**Falmouth Planning Board**  
**Select Board Meeting Room, Town Hall – January 13, 2026**  
**Meeting - 6:30 pm**  
**MINUTES**

**RE: Site Plan Review & Special Permit applications**  
**Applicant: Fashion Foods, LLC**  
**Lot 1B, 0 Worcester Court, Falmouth**  
**Assessors ID: 39 15 048 001B**

## Combined Review – Planning Board – Site Plan Review, Special Permit Zoning Board of Appeals – Special Permit Application 071-25

**LP-100**  
 (Updated 12-22-25)

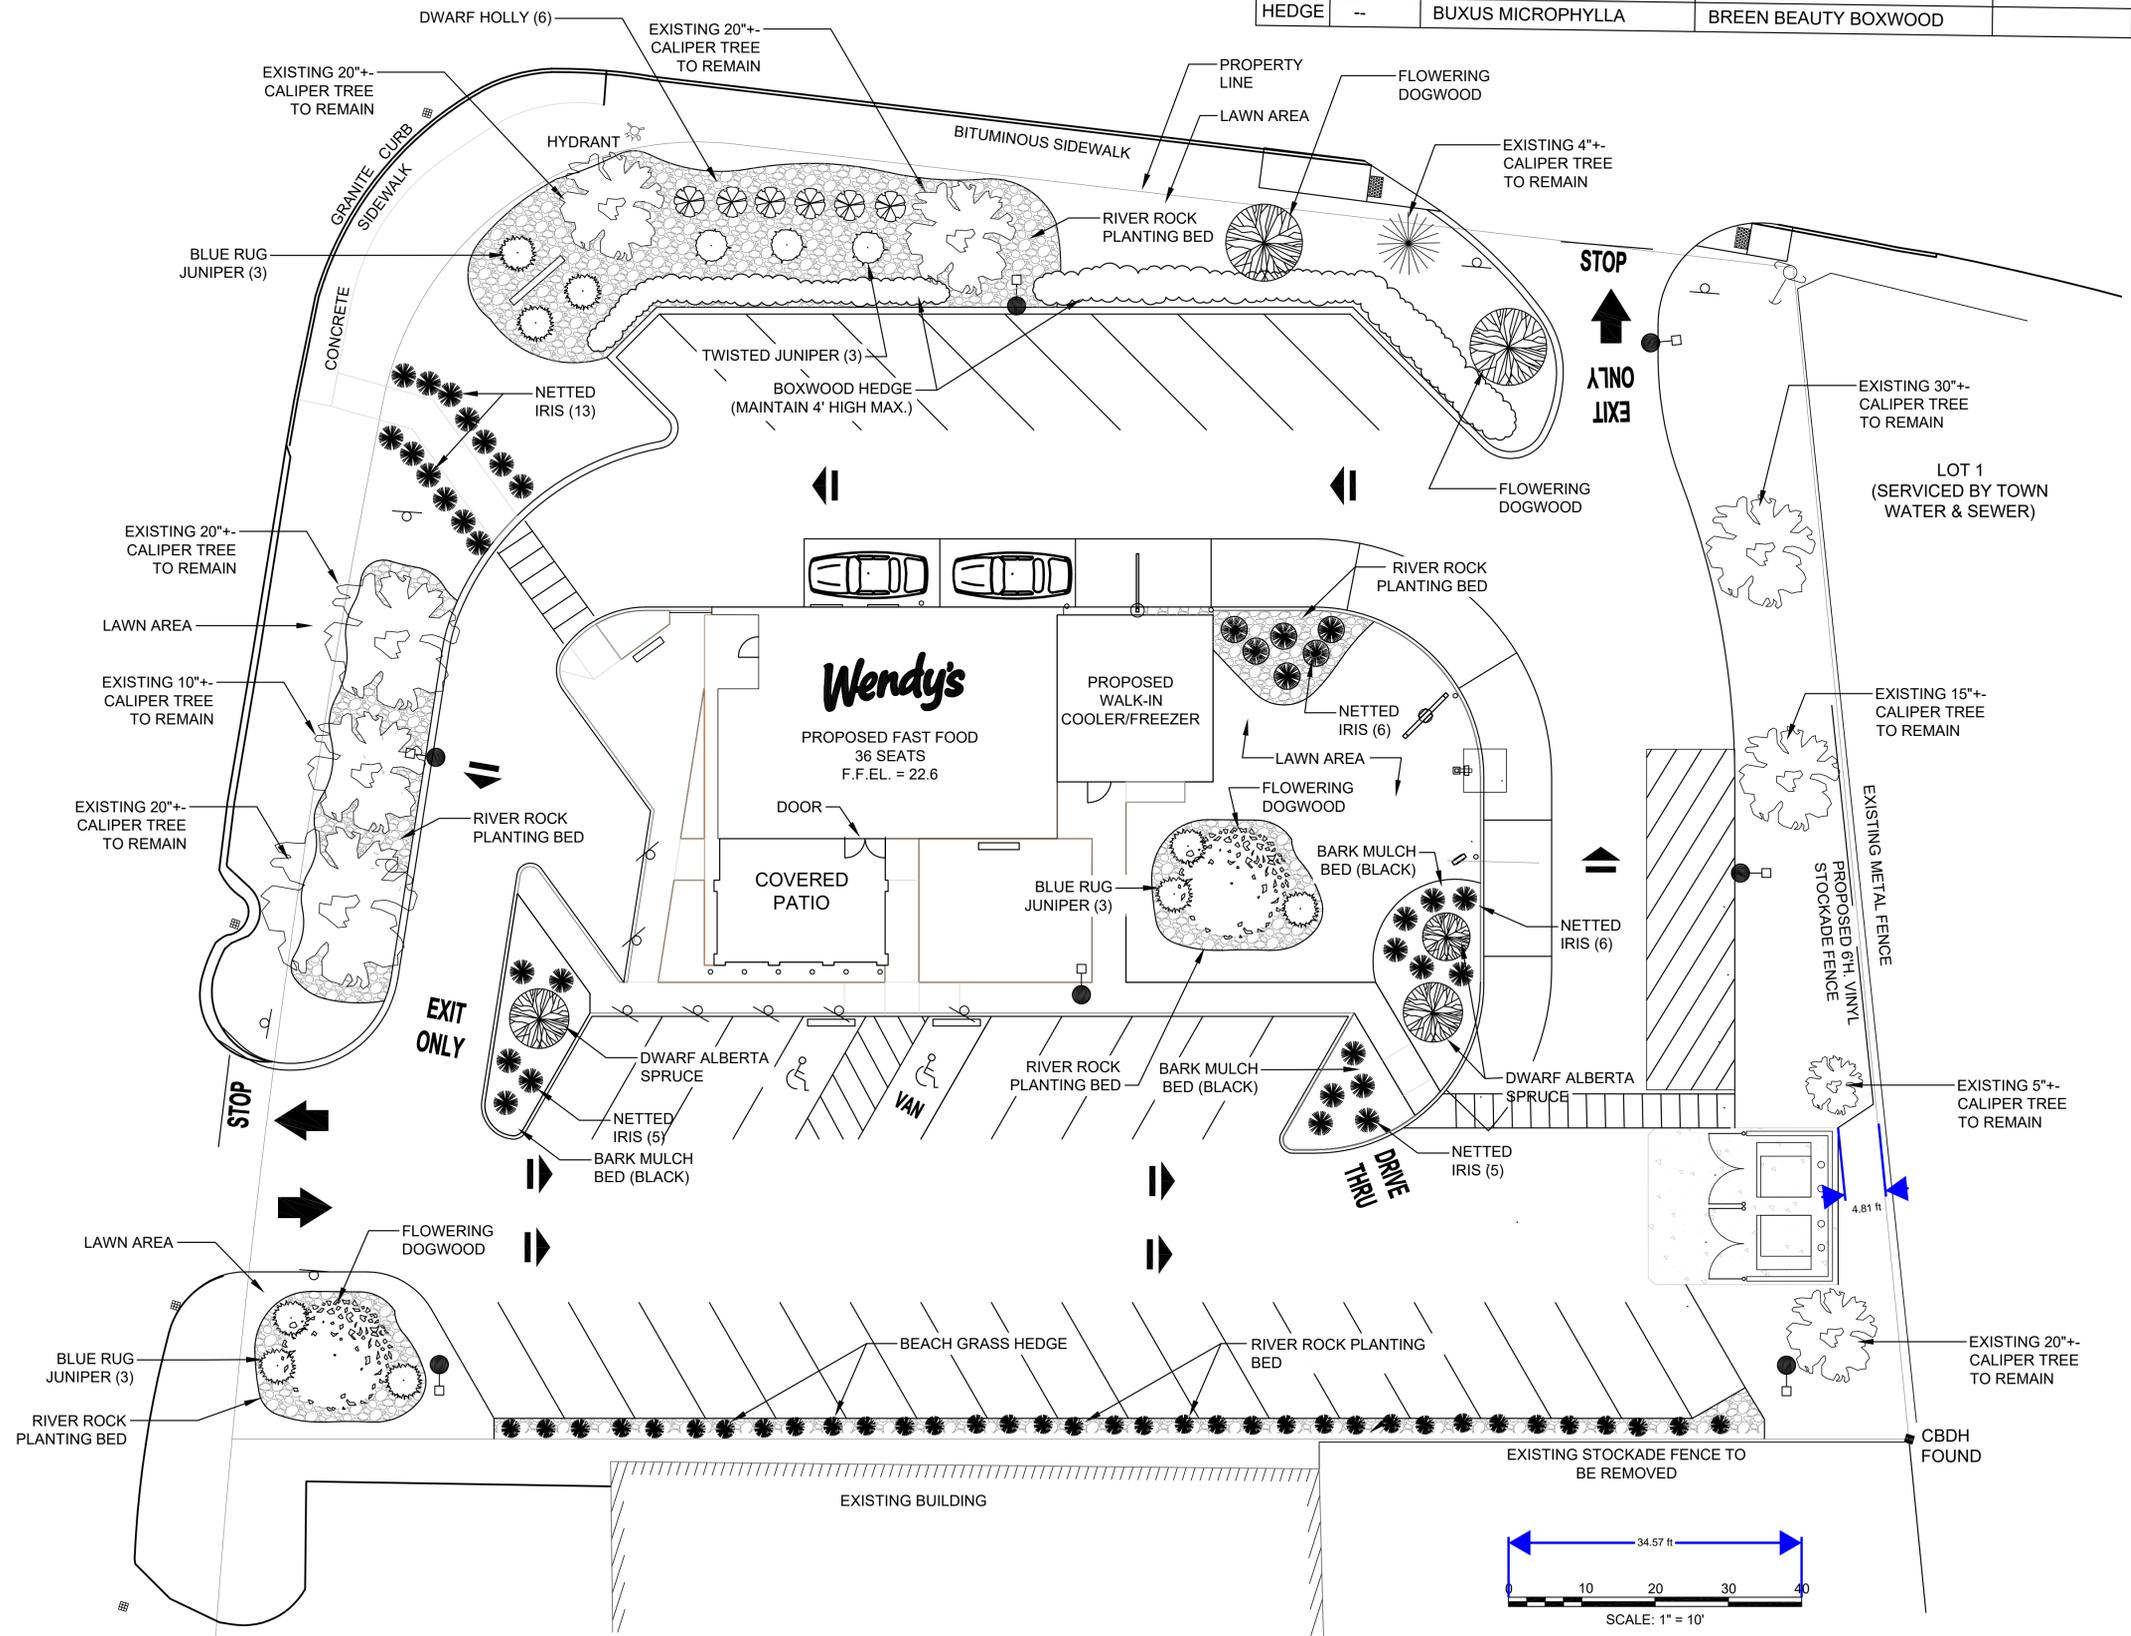
13. A landscape plan was included. It isn't clear if the parking lot and service area screening, vegetated islands for parking lot interiors, and residential buffer requirements are met.

The plans were revised to include additional screening with vegetation and fencing. The Boards should review the revised plans.

**No change in status. The site landscaping was revised; the Boards should re-evaluate.**

- D. Additional landscaping was added near the drive-thru area.

**The Boards should review the new landscape plan.**

6. The landscape plan has been revised for consistency with the latest Site Layout and to incorporate changes to the landscape design.
7. Additional landscape beds are proposed within the "green" space between Wendy's and the drive-thru queue aisle.
8. A Stormwater Management System Operation & Maintenance (O&M) Plan is provided. The O&M Plan informs the Planning Board of who is responsible for inspection and maintenance of the drainage system. The document also informs the necessary inspection

Drawing Title: GRAPHIC - MAIN DRIVEWAY  
SIGHT DISTANCE

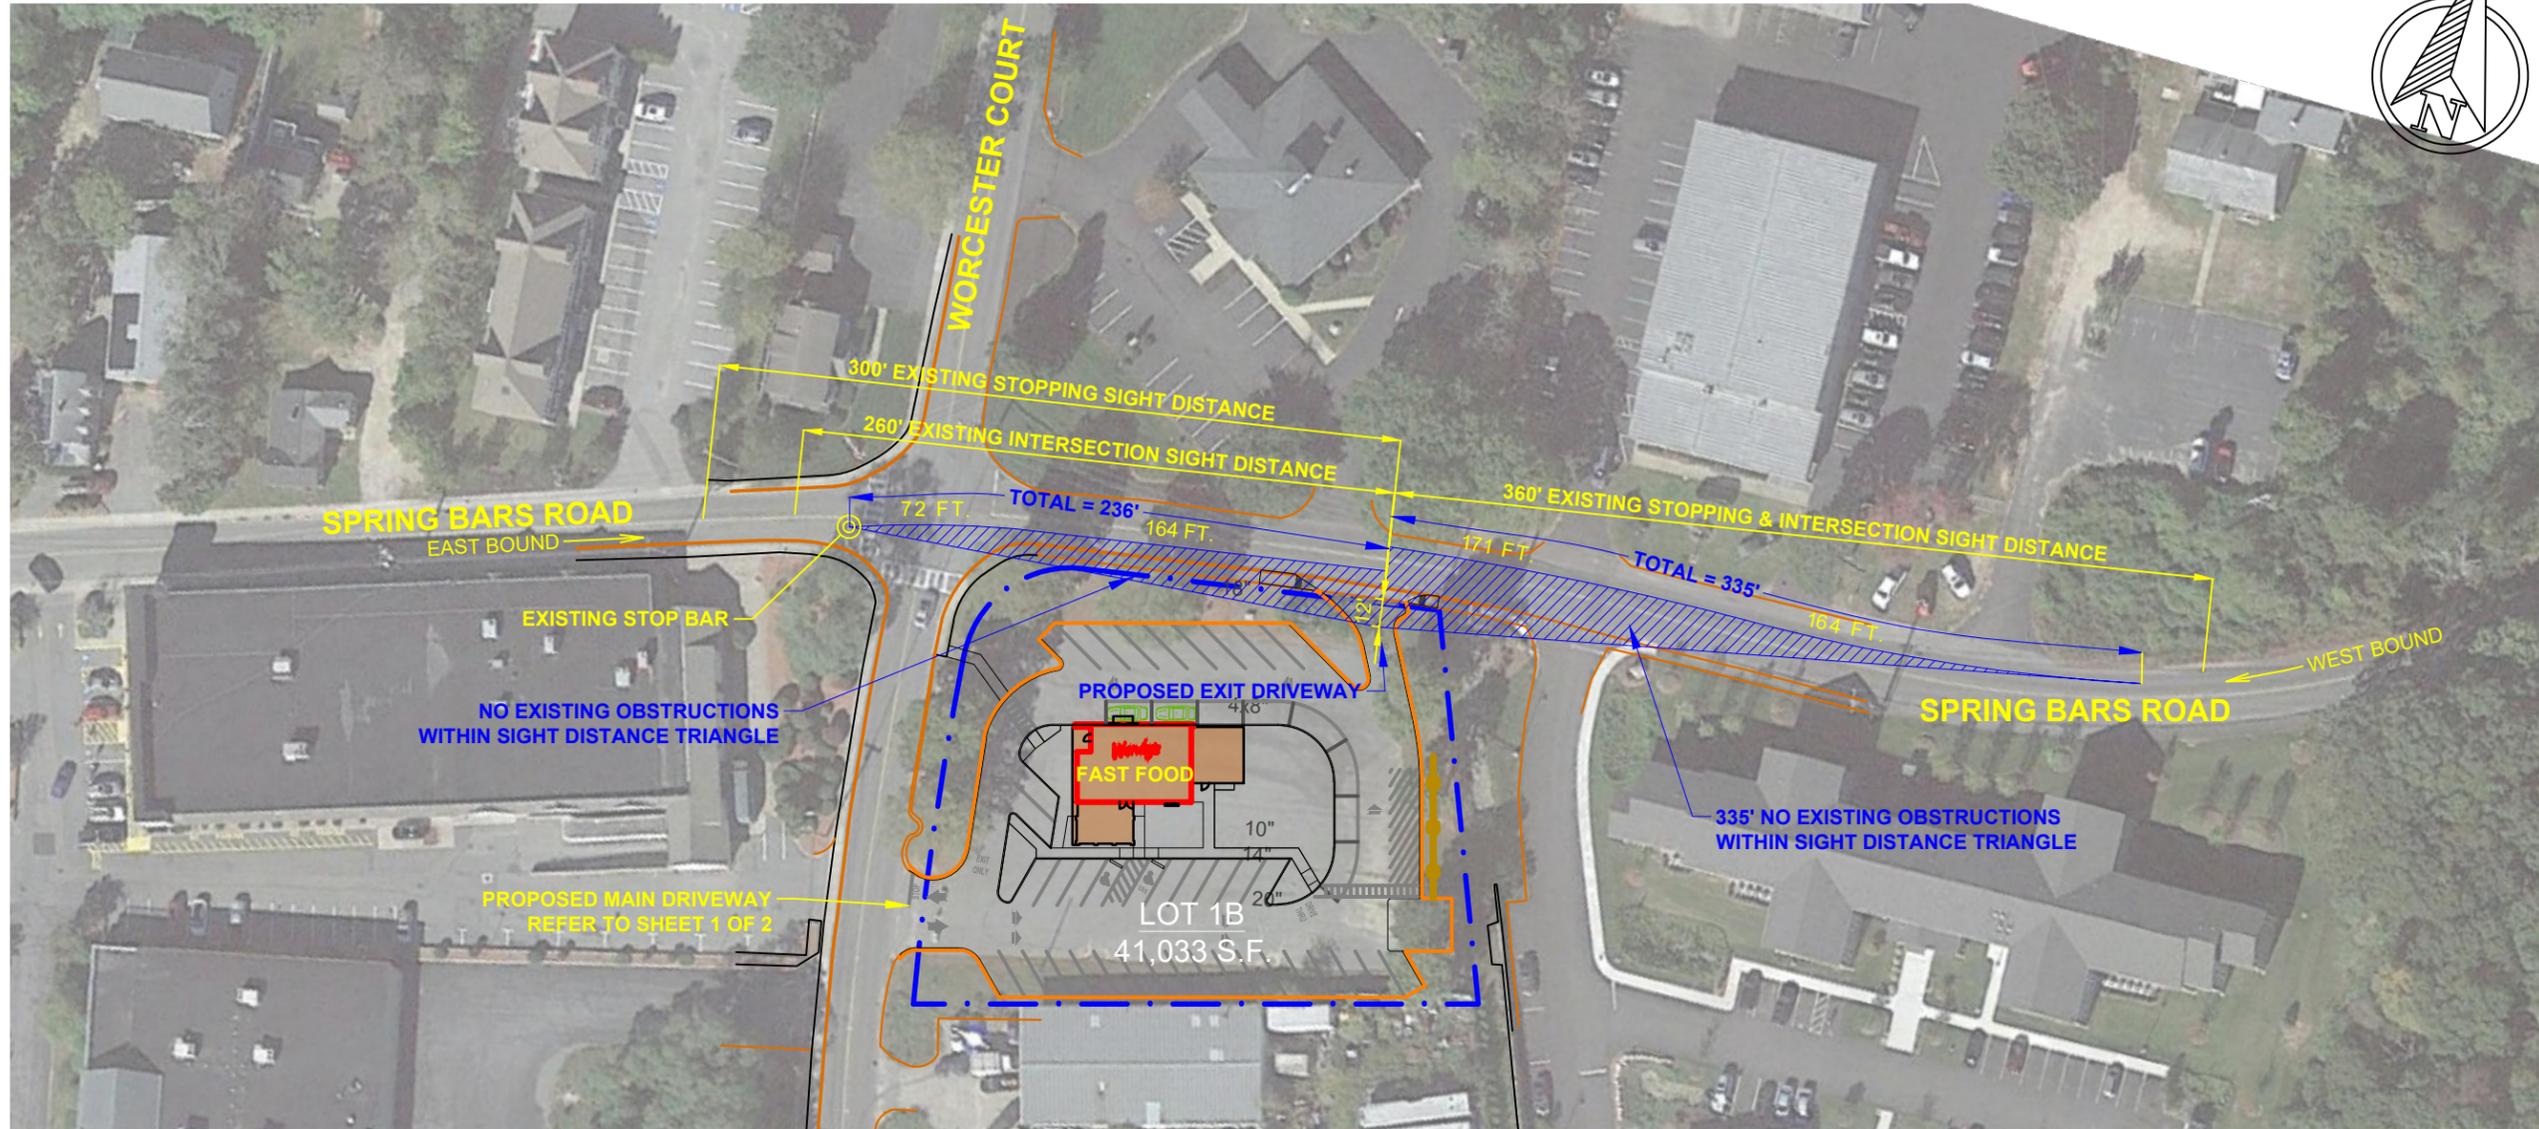
DPW Engineering will require updated sight distance sketches in the road permit application; Planning and Appeals should determine if these sketches should be submitted for their approvals.

*We believe this site can provide the sight distance we typically require as part of a street permit. As stated in our review, the measurement is the travelled path of the moving vehicle, see below example for non-straight road sections.*

*We will require sketches that show the clear triangles for 335-feet along the travelled path with the exception of the triangle towards the Spring Bars Road and Worcester Court intersection; the length of which is fixed to the car stopped at this intersection.*

**Comment addressed, the Applicant's Engineer has submitted sight distance sketches showing compliance as requested. We would accept and approve these sketches if submitted with a Street Opening Permit application.**

9. Although the sight distance triangle graphics submitted illustrate that drivers have sufficient unobstructed sight distance from the two driveways, these graphics have been revised to depict the 335-foot triangle sight distance as requested by the Town Engineer. This revision does not alter in any way the proposed site Layout or the proposed driveways.
10. A new graphic plan is provided to illustrate the recommended location for “Speed Radars” along Worcester Court. The recommended location of the “Speed Radars” are 475-foot north and 450-foot south from the Worcester Court – Spring Bars Road intersection. These two locations do not appear to interfere with existing roadways or driveways and appear to be in areas that receive enough sunlight to adequately power the system (solar cell energy).

REV. 12/18/25: REVISE BOTH SIGHT DISTANCE TRIANGLES TO ONLY 335-FOOT LENGTH ALONG TRAVELED LANE

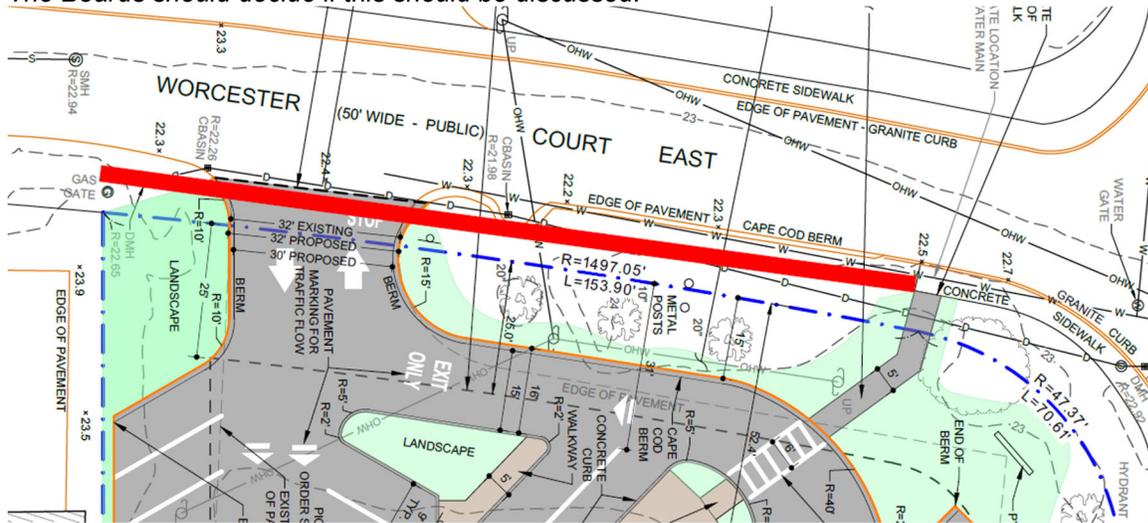
7. Both entrances exceed the maximum opening width in §240-14.11(4)b. The turning movement shown for the WB62 vehicle does show that additional width is required for this vehicle to access the site.

The Boards should determine if the Applicant has demonstrated that the greater width is needed.

*The Applicant’s Engineer indicates that the proposed driveway widths are required. We would not have an issue approving the additional width under a street permit.*

*The Boards should decide if the plans should be revised to meet the Zoning requirements, or if the Applicant’s Engineer has demonstrated the need for relief as allowed by §240-14.11(4)b.*

**No change in status.**

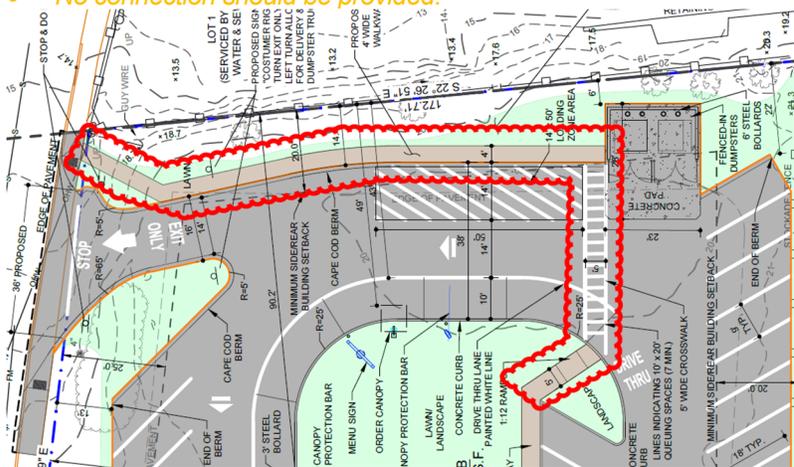
12. Has the Applicant considered providing pedestrian access from Spring Bars Road into the site?  
The Boards should decide if this should be discussed.

The plans were revised to include a sidewalk connection to the existing sidewalk in Spring Bars Road, however, the Applicant's Engineer offers reasons for not including this in the final design due to safety concerns. If a connection along Spring Bars Road is not included in the final design, pedestrians walking west on Spring Bars Road can access the site by walking up to Worcester Court to the sidewalk connection to the front door.

The revised plans do not include the sidewalk. The Applicant's Engineer indicates that the Architectural Access Board of Massachusetts has opined that this sidewalk would be required to meet the slope limitations for ADA accessibility.

- **The previously proposed pedestrian connection to Spring Bars Road should be revised to meet ADA compliance, or**
- **The proposed alternate route of continuing up Spring Bars Road to the walkway at the intersection with Worcester Court is acceptable.**

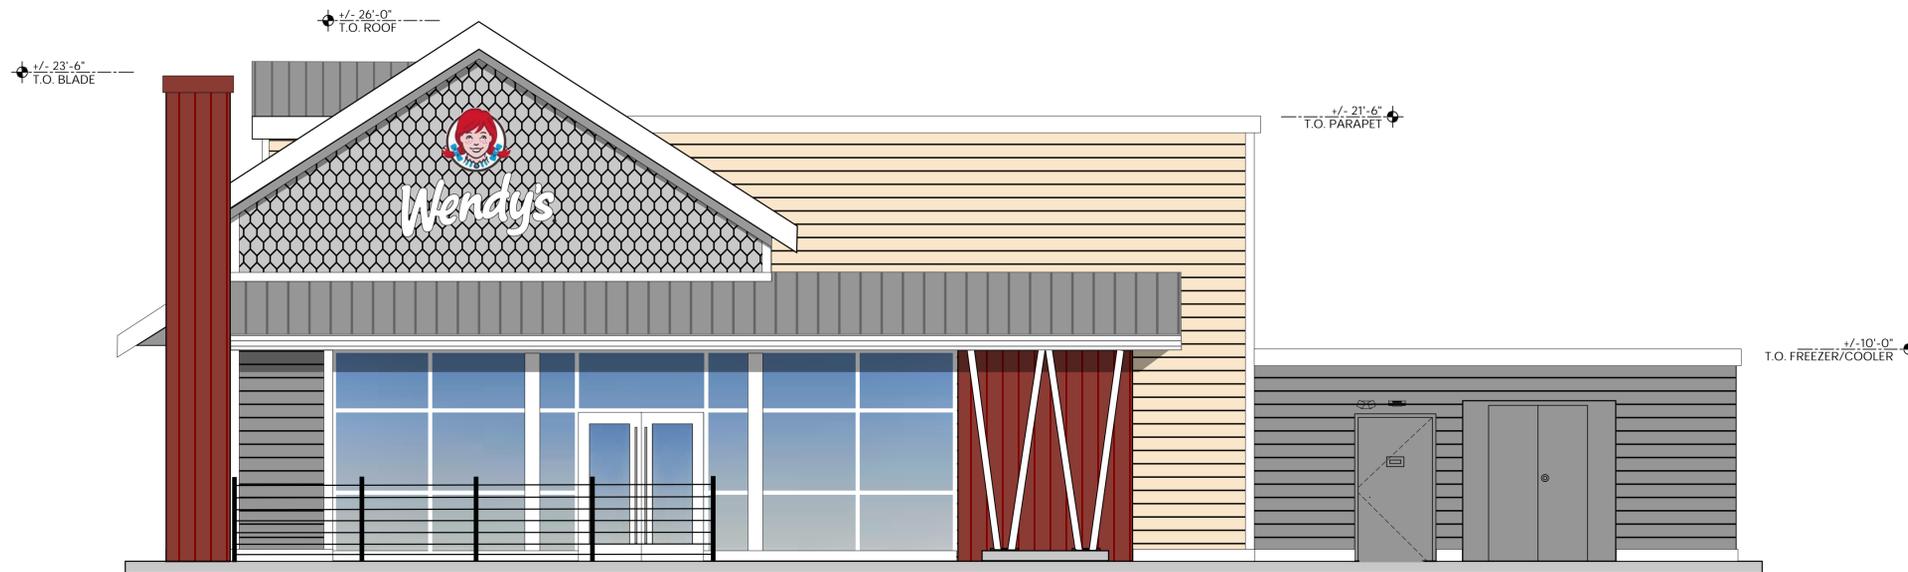
- F. A sketch showing where two "speed radars" should be located was submitted. It is not clear what the intent of this sketch is.
- a. Will the Applicant be purchasing and installing these?
  - b. Installation would require approval from the Traffic Advisory Committee. While similar installation locations have been approved in the past, not all have received Town funding and therefore not all have been installed.
  - c. Installation by a private contractor would require a street permit from the Department of Public Works Engineering Division.

**If the Boards intend to base their approvals of this project on the installation of the proposed "speed radars," the Board should determine whether:**

- **The installation should be approved and funded — whether privately by the Applicant or by the Town — before any project approval, or**
- **A condition should be included in the approval requiring that the devices be approved and installed. If the installation is not approved, or if it is approved but not funded, the Applicant must return to the Boards to request a modification of the approval.**

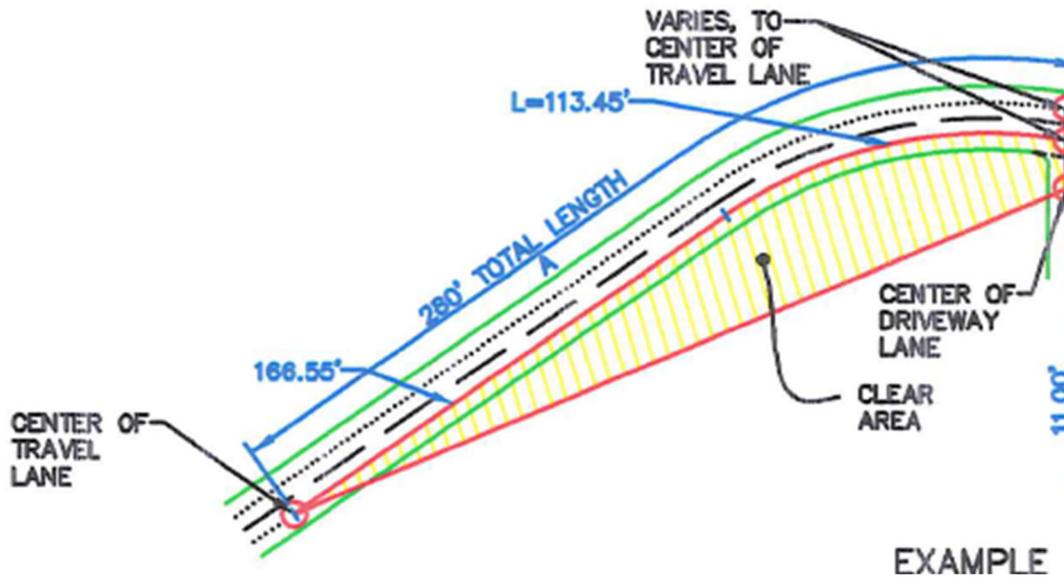
Worcester Ct is posted 30 MPH; 335-feet would be required in both directions, and Spring Bars Road is 30 MPH by default; 335-feet would also be required in both directions. Note that the Worcester Ct and Spring Bars Road intersection would be the limit of the sight distance triangles in those directions.

Sight distance is measured along the approach vehicle’s travelled path.

The Spring Bars Road clear triangle should take into account the elevations of the ground within the triangle.

The Boards should decide if the site plans should be revised.
